29 November 2021
Ref 20355

SSD-8859
PROPOSED SUBDIVISION
1111-1141 ELIZABETH DRIVE, CECIL PARK
TRAFFIC MATTERS

SSD 8859
PROPOSED SUBDIVISION
1111-1141 ELIZABETH DRIVE, CECIL PARK
SITE ACCESS MATTERS

Figure 3.2: Safe intersection sight distance (SISD)

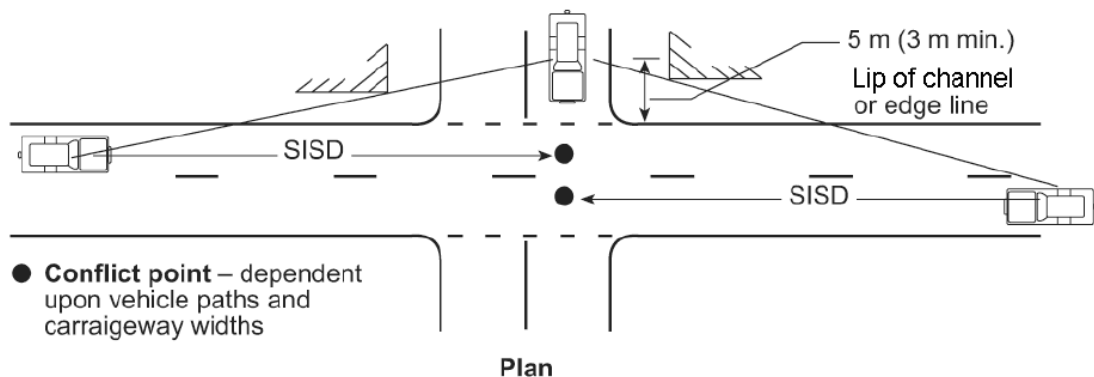
- b. The traffic report p.11, shows a proposed left turn slip lane from the realigned Wallgrove Road onto the access road (access to the subject site), which also continues after the access road to form two lanes on the realigned Wallgrove Road continuing to the intersection with Elizabeth Drive. This will potentially cause significant safety and operational issues as traffic turning in and out onto and from the access road would assume these vehicles on the kerb side lane are turning left onto the access road, however, these vehicles may choose to continue to travel straight on Wallgrove Road. Further, visibility and sightlines for traffic exiting from the access road would also be restricted by traffic travelling along the kerb side lane before the proposed access road.

The critical turning movement for driver visibility is the left turn out of the proposed new subdivision road onto the new realigned Wallgrove Road.

Reference to Austroads *Guide to Road Design Part 4A: Unsignalised and Signalised Intersections*, Section 3.2.2 sets out the design requirements for SISD, which is the minimum sight distance which should be provided on the major road at any intersection. Diagrammatically, SISD is illustrated in the Austroads extract below.

Proposed new “half seagull” intersection treatment

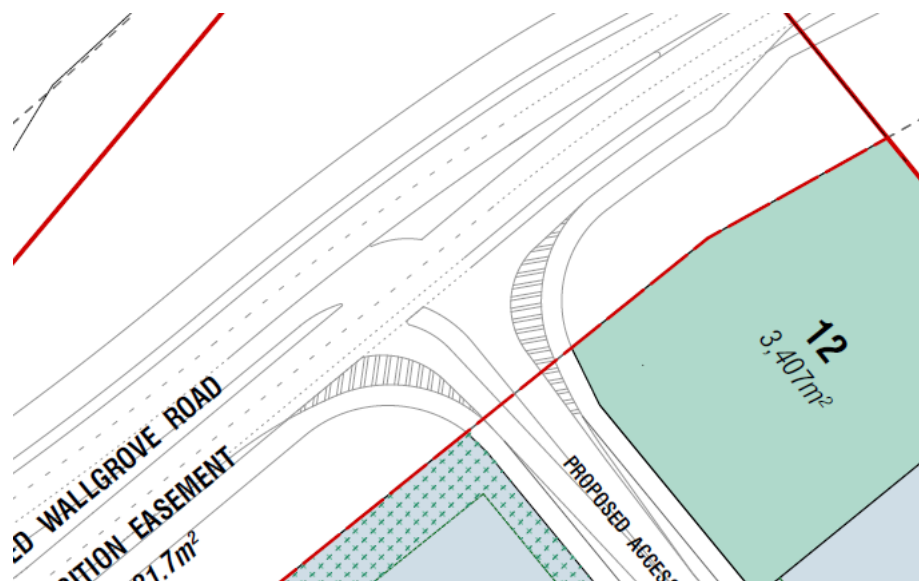
3. A road safety audit is also required for the proposed access arrangement to the site given the above concerns.

- sight distance for vehicles turning left out of the subdivision road back onto Wallgrove Road, particularly in the instance where a vehicle is also turning left into the subdivision road whilst utilising the left-turn slip lane,
- the width and kerb return radii at the proposed new subdivision intersection and the angle at which smaller vehicles may be placed as they turn left out of the subdivision road back onto Wallgrove Road, and
- the offset distance between the proposed new subdivision intersection and the start of the right turn bay at the new Wallgrove Road & Cecil Road traffic signals

With respect to *MU Group's* sight distance concern, the RSA notes that a SISD of 150m is achieved when the left-turn slip lane is clear, however is reduced to 84m when a left turning vehicle is *within* the slip lane.

As noted in the foregoing, the road design of the future Wallgrove Road realignment is still a work-in-progress, however it is evident that the 151m SISD requirement can be achieved. In terms of the reduced SISD when a left turning vehicle is *within* the slip lane, this “moment in time” will be short-lived. Based on the traffic generation potential of the subdivision, there will not be a constant procession of left turning vehicles into the subdivision. Once the left turning vehicle has entered the subdivision, the available visibility will return to 151m. Furthermore, a left turning entering vehicle does not automatically grant a left turning exiting vehicle right-of-way to pull out into the main road traffic flow. The left turning exiting driver must display caution at all times and wait until they are completely satisfied there is a sufficient gap in traffic flow before exiting, as per the NSW Road Rules. This arrangement is typical and commonplace in today's urban environment and considered acceptable.

With respect to *MU Group's* concern regarding the angle of exiting vehicles, this is simply rectified by the inclusion of linemarking, as illustrated in the screenshot image of the concept plan below. The extent of linemarking illustrated in the concept plan is based on the swept turn path requirements of an 8.8m long MRV truck, noting that the intersection has been designed to accommodate B-Triples. Larger trucks will therefore traverse over the linemarking which is also commonplace and acceptable in today's urban environment.

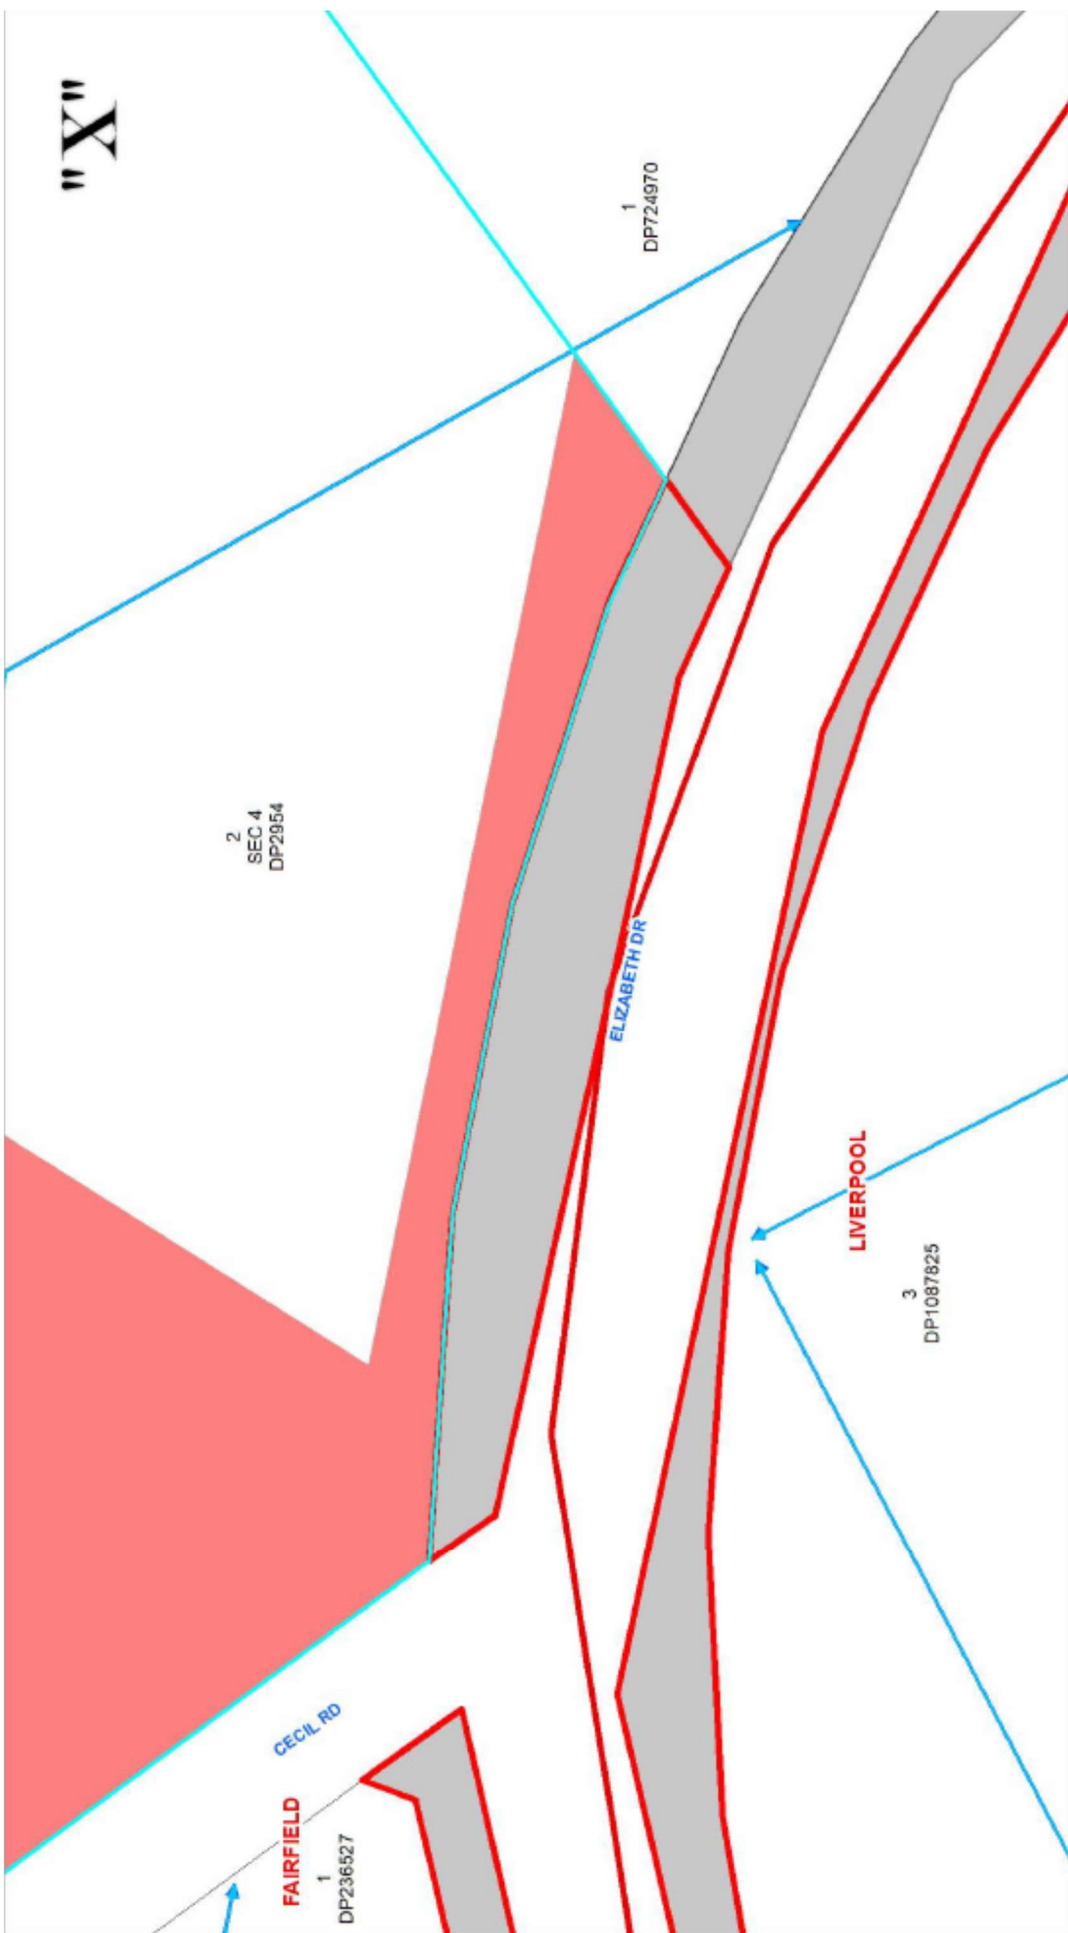
Additionally, TfNSW has previously vested a strip of land as road along the Elizabeth Road frontage of the subject property, as shown by the grey colour on the attached Aerial – “X”.

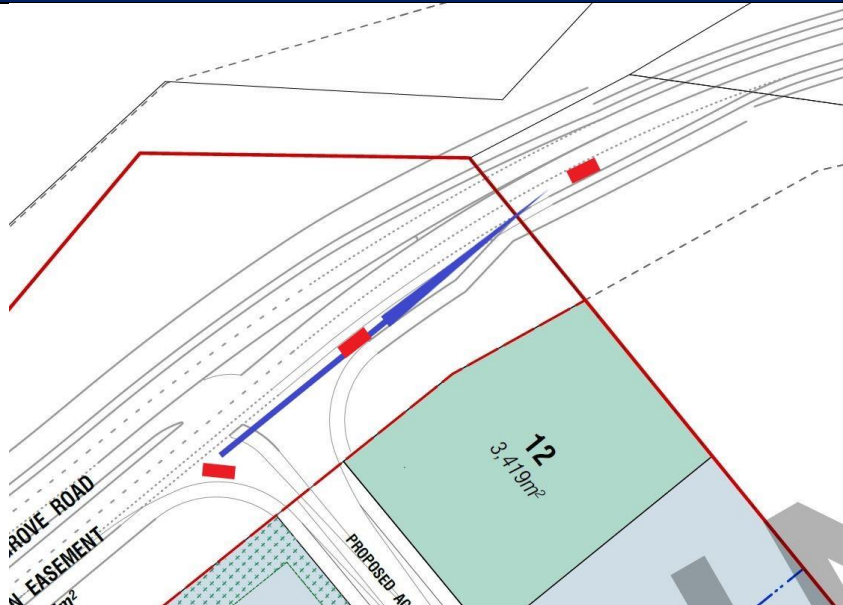
Ref No.	Photos / Site Description / Safety Issue	Description of risk to road safety (Reason why this is a safety issue)	Road Safety Audit Category	Probability	Severity	Risk Rating
1	 <i>Design plan showing left turning vehicle from proposed site access.</i> <i>Austroroads requirement (Guide to Road Design Part 4A, Table 3.2) for SISD at 70km/h: 151m</i> <i>SISD Achieved in current design with left turning vehicle: 84m</i> <i>SISD Achieved in current design with left turning vehicle: 150m</i>	Safe intersection sight distance for left turning vehicles out of the access road is not achieved to southbound vehicles in Wallgrove Road. Drivers may become impatient and pull out into the southbound travel lane on Wallgrove Road with insufficient gaps in the traffic causing rear-end and intersection type crashes. This issue could be exacerbated by the vertical alignment on Wallgrove Road (not assessed under this safety audit) as well as the presence of vehicles turning left into the development. It is noted that other options have proposed an intersection further north on Wallgrove Road. This does not improve the safety risk described above due to the presence of the horizontal curve in Wallgrove Road and the terminating leg of the T-intersection being on the inside of the curve.	Intersections	Yearly	Serious	Medium

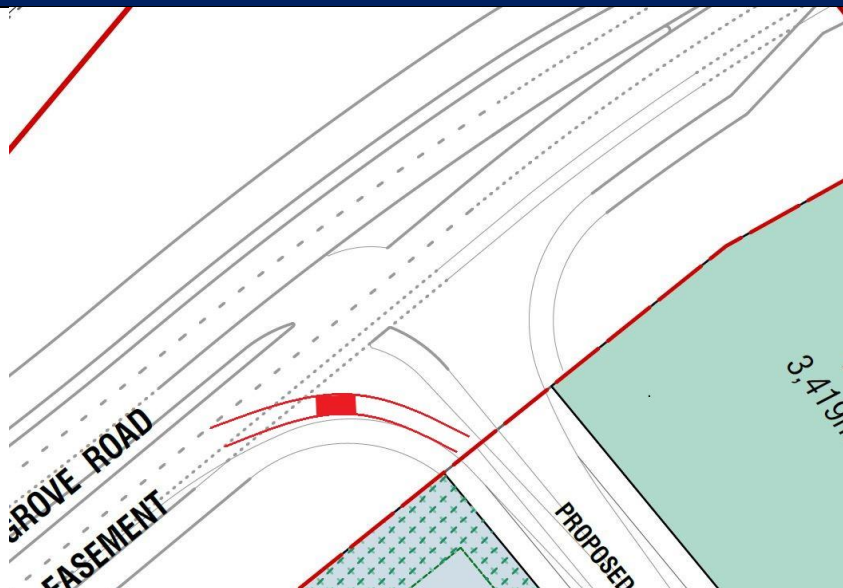
Ref No.	Photos / Site Description / Safety Issue	Description of risk to road safety (Reason why this is a safety issue)	Road Safety Audit Category	Probability	Severity	Risk Rating
2	 Design plan showing left turning vehicle following kerb line and stopping at the give way line.	The width and kerb return radii at the access road exit appears to be excessive. This will result in vehicles stopping at the give way line at an undesirable angle to oncoming traffic, increasing the likelihood of crashes highlighted in Risk 1. Drivers may also attempt to turn two abreast given the significant width at the intersection or illegally make a right turn out of the proposed access road resulting in right-through and rear-end crashes.	Intersections	Yearly	Serious	Medium

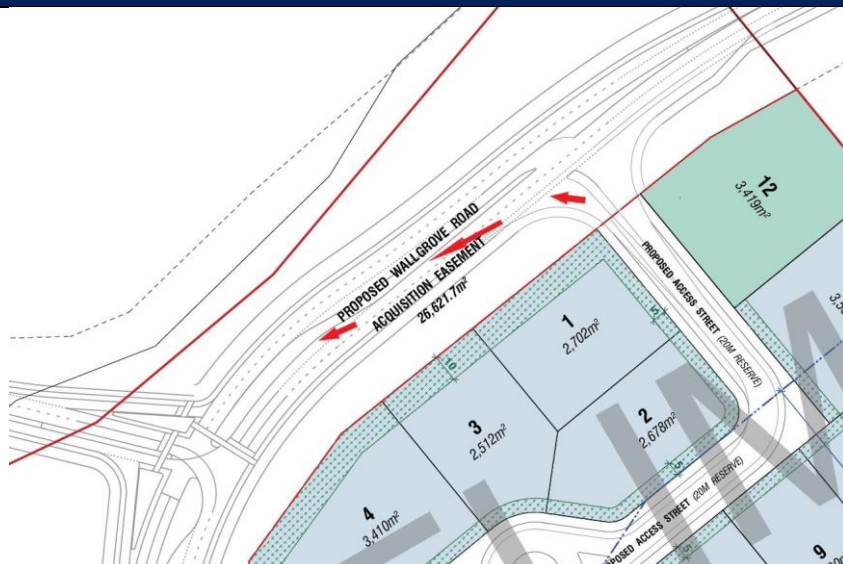
Ref No.	Photos / Site Description / Safety Issue	Description of risk to road safety (Reason why this is a safety issue)	Road Safety Audit Category	Probability	Severity	Risk Rating
3	 <i>Design plan showing vehicle path from the site access to the right turn bay for Cecil Road.</i>	Turning left out of the development access road and right into Cecil Road requires attaining a suitable gap in the southbound traffic on Wallgrove Road and then changing across one lane to enter the right turn bay. The distance available to carry out this sequence of manoeuvres is insufficient, and drivers may have to force their way through. This disruption to the traffic flow may be worsened if the right turn bay has several vehicles already waiting in it. Rear-end and lane change crashes could occur as a result of this geometry.	Intersections	6 Monthly	Moderate	Low

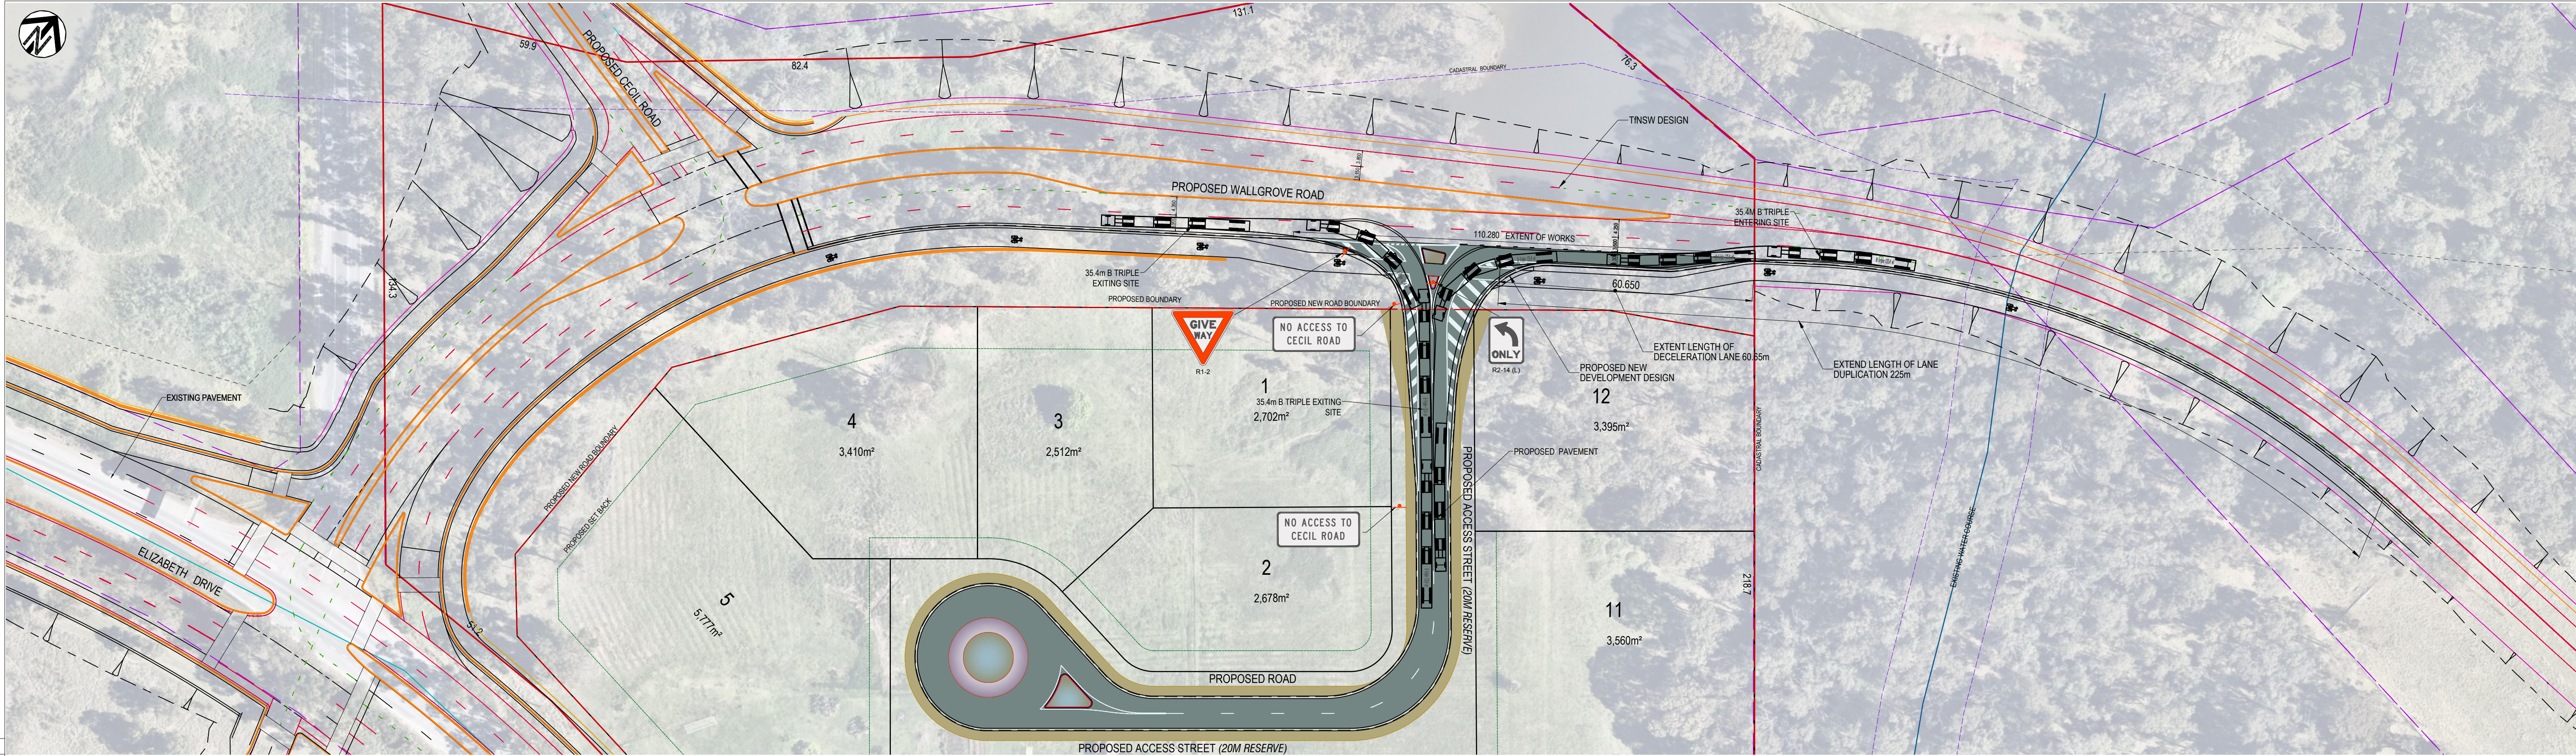
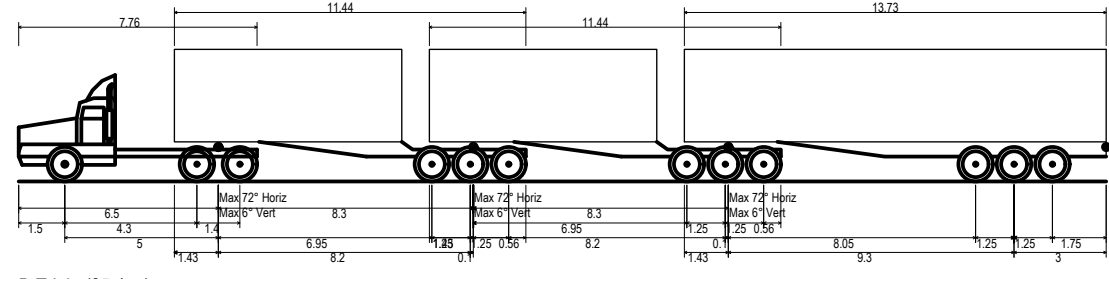
- Council has not approved the operation of B-Triple vehicles in the Fairfield Local Government Area as their impacts on local road network are unknown. The use of B-Triple vehicle shall be justified by swept path analysis to indicate that the B-Triple vehicle can satisfactorily travel to and from the site without impacting other road users and whether compliance with the NSW Road Rules can be achieved. Field trial may be required to ascertain whether the proposed access road is suitable to accommodate heavy vehicles.

Written advice received from TfNSW (attached) is that the design vehicle should be a 26m long B-Double whilst the checking vehicle should be a 30m long PBS. Sheet 2 & 3 of the attached *MU Group* design drawings includes swept turn paths of both trucks.
